ADDENDUM 2

LIVESTOCK SPRINGS

PROJECT NUMBER: 7264-B HREC

UNIVERSITY OF CALIFORNIA, HOPLAND RESEARCH AND EXTENSION CENTER

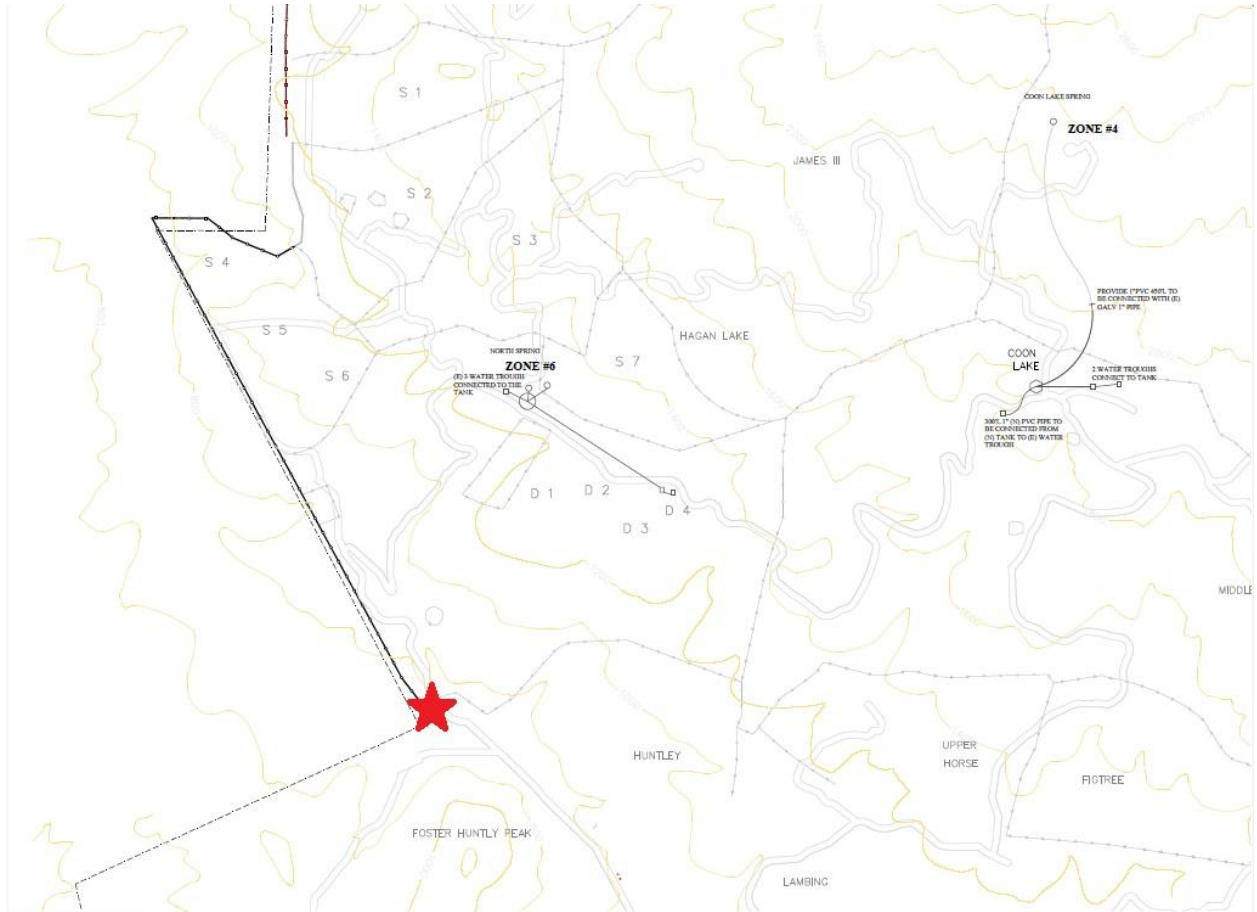
1. Below is the site plan showing the staging area.
2. All tank installations shall include appropriate air gap separation from spring source to holding tank as part of the plumbing to ensure continuous flow of source.
